Comment 38 - request to exit LPI

April 2019

Comment 38

Figure 149–15—PCS 64B/65B Transmit state diagram, part b

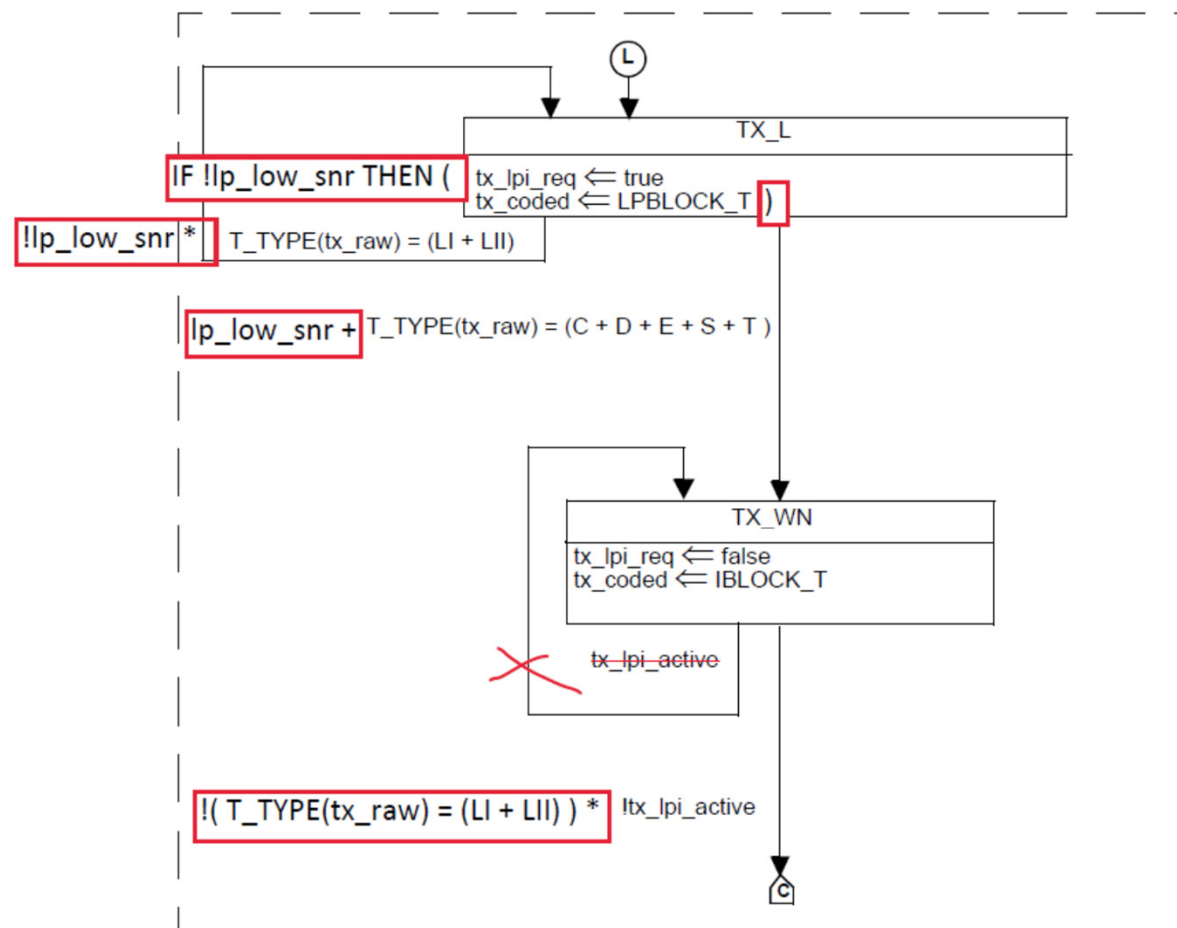
- ▶ Remove the editor's note in 149.3.8.2.5
- ▶ Create a new variable in 149.3.6.2.2 to represent the link partner low SNR condition:
 - `lp_low_snr` Set TRUE when the link partner indicates LPI refresh is insufficient to maintain PHY SNR. It is set false otherwise.
- ▶ Modify Fig 149–15 (PCS 64B/65B Transmit state diagram) as follows:
 - Change the assignment inside state TX_L to prevent entering LPI

```
IF !lp_low_snr THEN ( tx_lpi_req <= true
                    tx_coded <= LPBLOCK_T )
```
 - Change the transition condition from TX_L to TX_WN to exit LPI for low SNR

```
lp_low_snr + T_TYPE(tx_raw) = (C + D + E + S + T)
```
 - Change the transition condition from TX_L to TX_L to balance other path

```
!lp_low_snr * T_TYPE(tx_raw) = (LI + LII)
```
 - Change the transition condition from TX_WN to TX_C, wait for RS to stop LPI

```
!tx_lpi_active * !( T_TYPE(tx_raw) = (LI + LII) )
```
 - Remove the loopback path from TX_WN to TX_WN, it is unnecessary.

- ▶ When the link partner indicates low SNR, the TX state machine will gracefully exit low power idle and stay in the Wake state sending Idles until the RS stops indicating LPI on the XGMII.
- ▶ Upon exit from Wake into normal Idle/Data, if the RS again presents LPI at the XGMII the TX state machine will not send the SLEEP signal and will not enter the low power idle state, but instead move to the Wake state and send Idles until the RS stops sending LPI.
- ▶ With these changes on the TX PCS side, no modifications are needed on the RX side and no changes are needed to the EEE state machine.
- ▶ There is no interruption to data in the receive path.
